Annexure A: Email from Ian McCabe

Annexure B- Letter from the Transport Agency

Proposed Queenstown Lakes District Plan – Correction of Errors

**Annexure C- Relevant Council Recommendation, Decision and Plans for RM120413 - New
Kawarau Falls Bridge**

TITLE: CONCEPTUAL LANDSCAPE DESIGN SHEET 2 OF 2 NORTHERN ABUTMENT

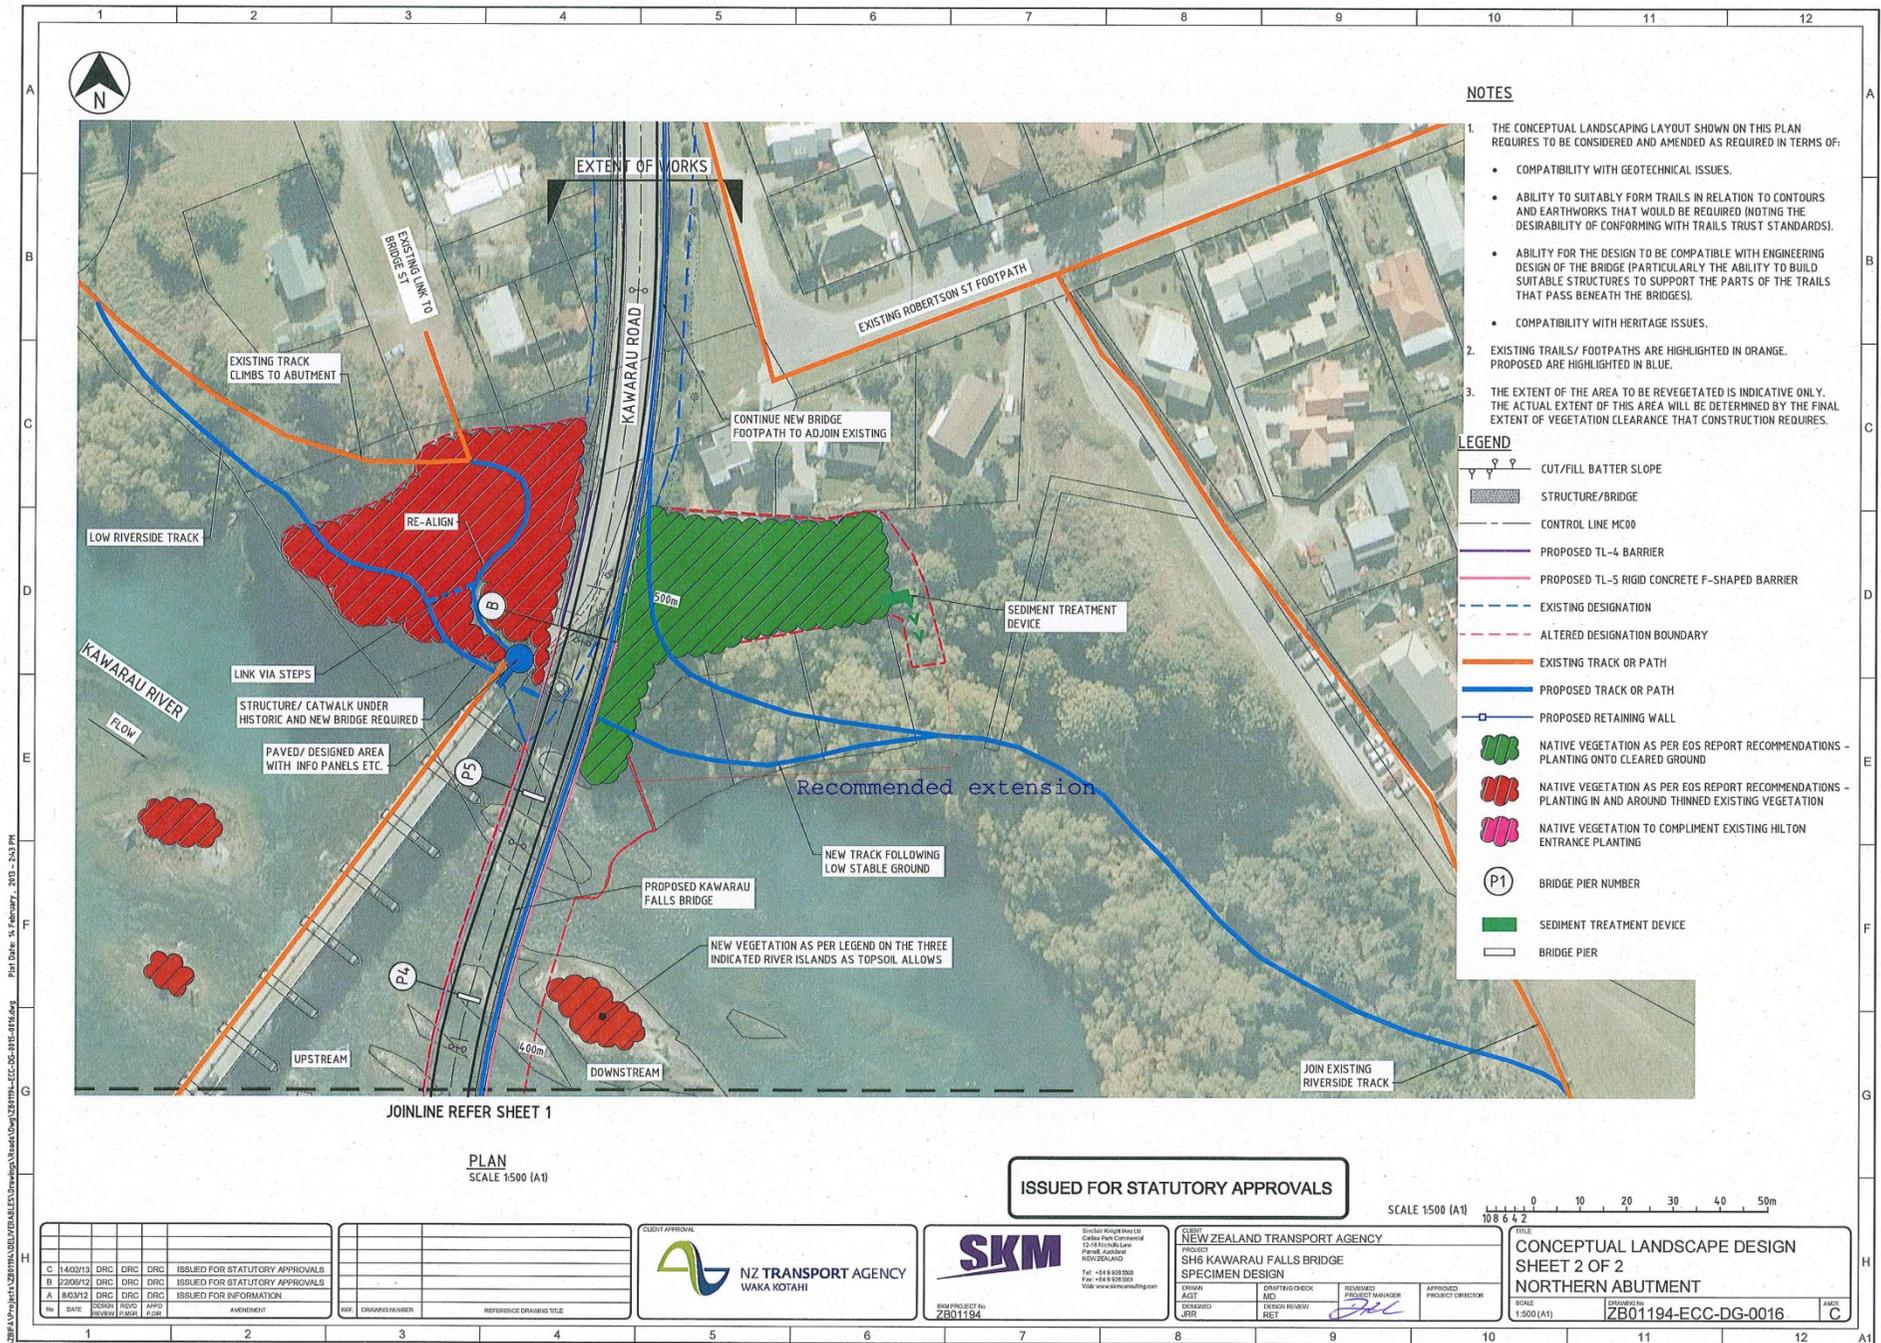
78. At the northern abutment the proposed bridge passes over the northern abutment of the existing bridge with a clearance of some 50mm.²⁶ The Conceptual Landscape Design drawings show a horizontal gap between the paved area at the northern end of the existing bridge and the new bridge of some 3-4m.²⁷

84. We consider that the failure of NZTA to link the northern underpass with the track alongside SH6 east of the highway and bridge is inconsistent with the Project objectives of improving the experience for walkers and cyclists and of promoting an integrated land transport system. In our view, if the northern underpass is to have the function of providing a grade-separated crossing of the State highway, then connections to the cycle/pedestrian network needs to be provided at each end of the underpass. We therefore recommend that the NOR be modified by extending the designation to include the track shown on Sheet 2 of the Conceptual Landscape Design³¹ as “new track following low stable ground” to the point it intersects with the track shown on the same plan as running south and east from alongside SH6. We attach in Appendix 3 Sheet 2 with the approximate area we consider needs to be included within the designation shown as a solid red line.

~~23.22.~~ The ULDMP shall be consistent with the Landscape Concept Plan as outlined in NOR drawings ZB01194-ECC-DG-0015 (dated 14/02/13) and ZB01194-ECC-DG-0016 (dated 14/02/13, but with the "Recommended Extension" added, which is shown as a solid red line in Appendix 3 to the Commissioners' Recommendation) prepared for NZTA by Sinclair Knight Merz Ltd, and include the following:

Figure 1: Current Designation in Yellow with proposed designation overlaid (shaded)

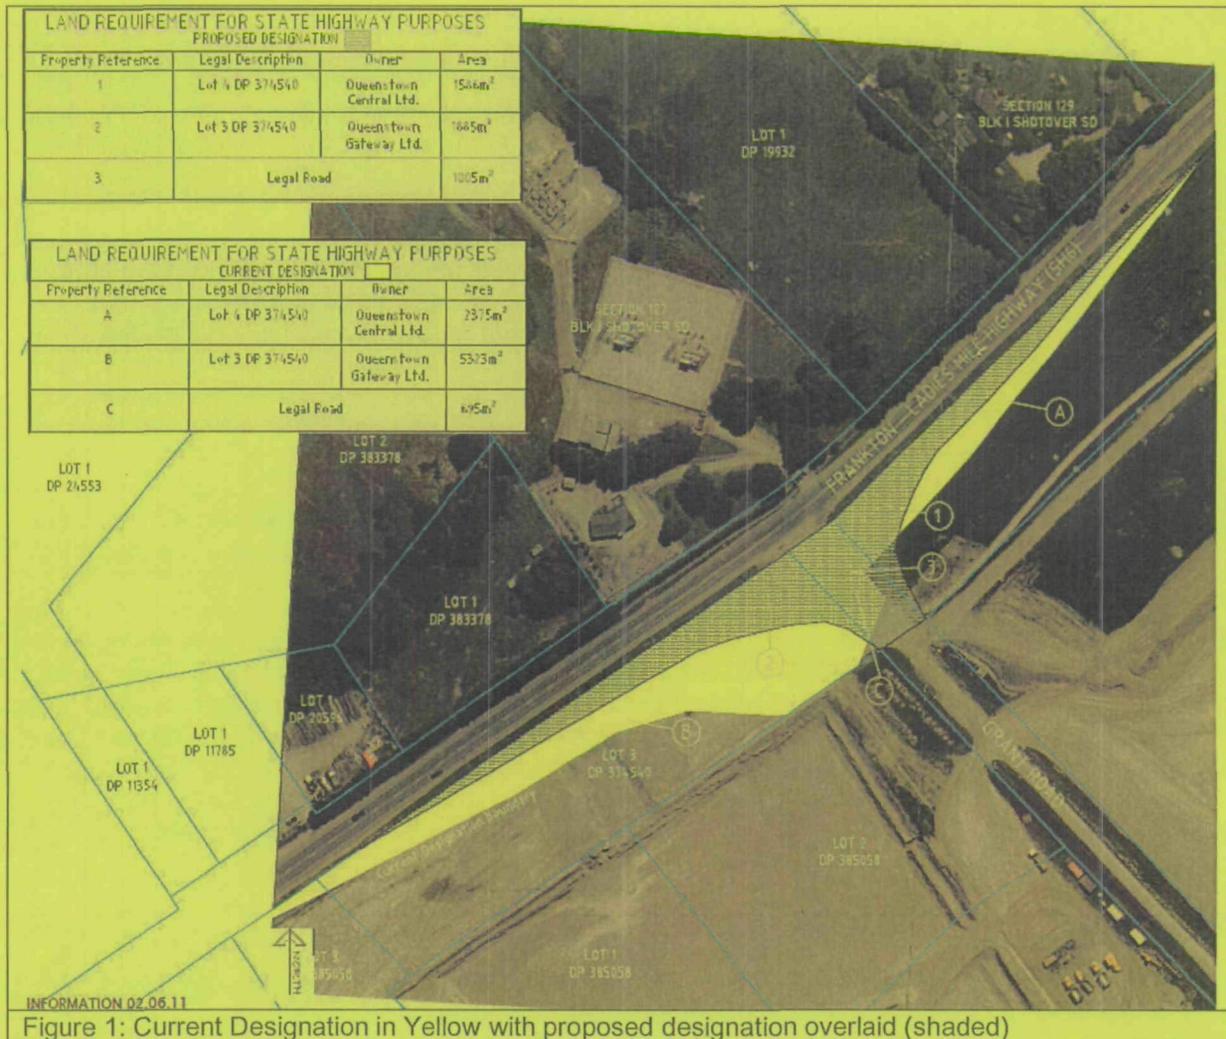
- 11) The NZTA also anticipates that as part of this process the designation over the land that is no longer required for State Highway purposes (coloured yellow on Figure 1 of RM1 10290) will be removed from the District Plan.
